ADDENDUM TO  
FLOOD RISK ASSESSMENT FOR  
HECKINGTON FEN WIND FARM

Job Number 3513842A-SSR

<b>Report Title</b>	:	<b>Addendum to Flood Risk Assessment for Heckington Fen Wind Farm</b>
<b>Report Status</b>	:	<b>Final</b>
<b>Job No</b>	:	<b>3513842A-SSR</b>
<b>Date</b>	:	<b>January 2015</b>

**Figure: 3.3**

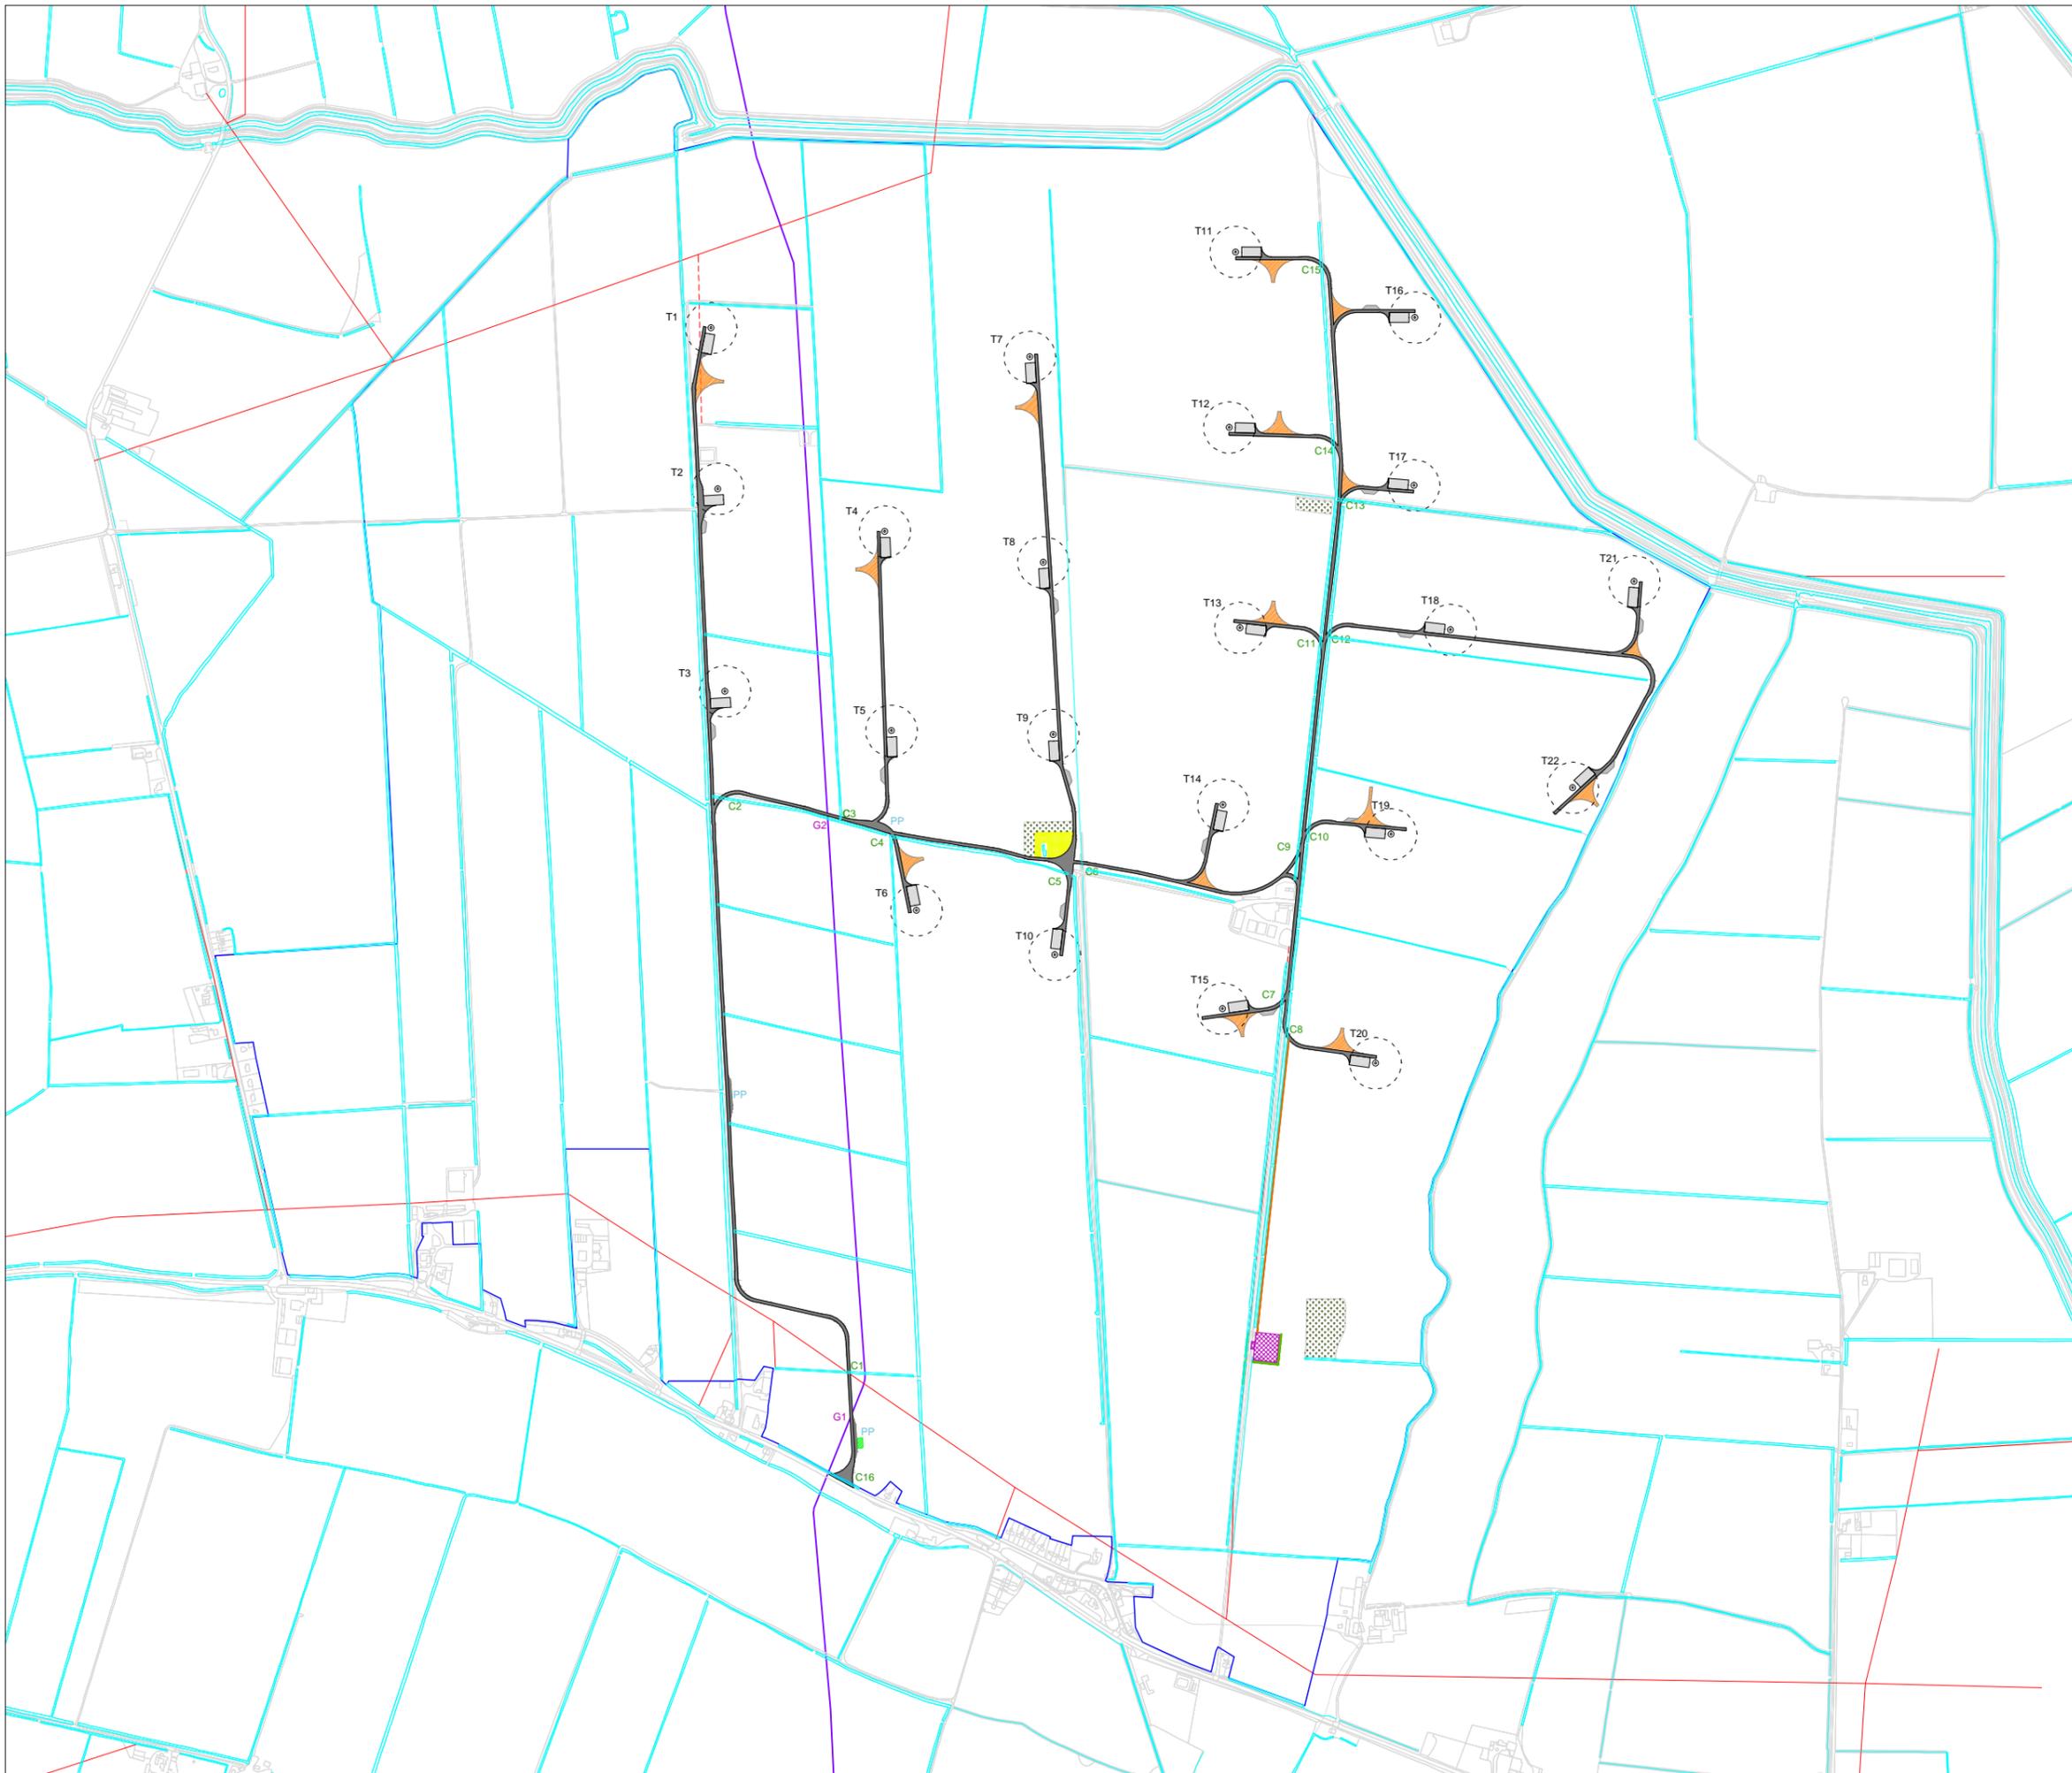
- Realignment of the onsite access track and increase in track levels (the original FRA did not take into account a 150mm raise in the access tracks);
- Relocating and increasing the footprint of the onsite substation, and moving from Flood Zone 1 to Flood Zone 3a; and
- Relocating the temporary construction compound approximately 200m to the west of its proposed original location (both locations are in Flood Zone 3) and increasing the compound footprint.

Title: Indicative Substation Levels

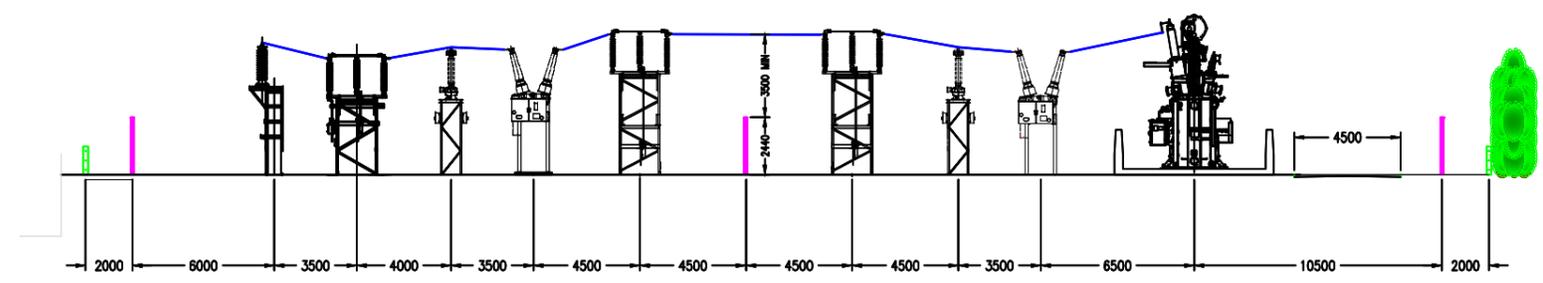
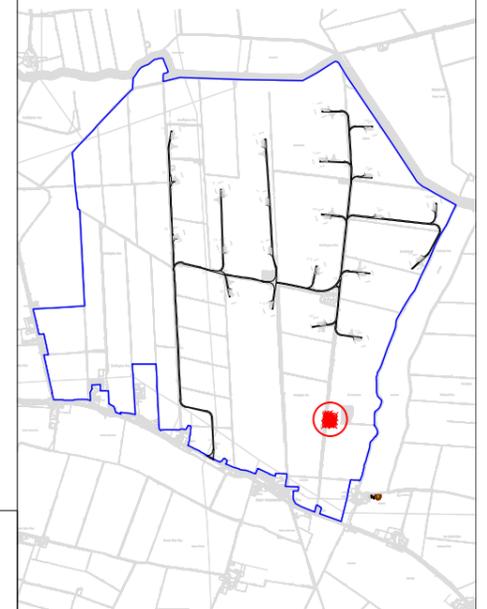
- 7.1.5 The sub-station compound is proposed to be located partially in Flood Zone 2 and partially in Flood Zone 3. Ground levels in the area of the proposed sub-station vary between approximately 2.2m AOD and 2.9m AOD. This area will be levelled at 2.6m AOD in alignment with the levels of the adjacent 600 Hundreds Drove track. Lowering the ground levels of the area of the sub-station to 2.6m AOD will locate this area within the 100 year flood extent. The threshold level of the sub-station control building will be raised 0.5m above the predicted 1000 year with climate change flood level (3.54m AOD) and will have a footprint of 135m<sup>2</sup>. The bounded area of the transformer will have a footprint of approximately 100m<sup>2</sup>. Construction of the sub-station building and the bounded area will displace approximately 70.5m<sup>3</sup> of the existing floodplain. A drawing showing the existing ground levels throughout the proposed sub-station area is shown in **Appendix F**.
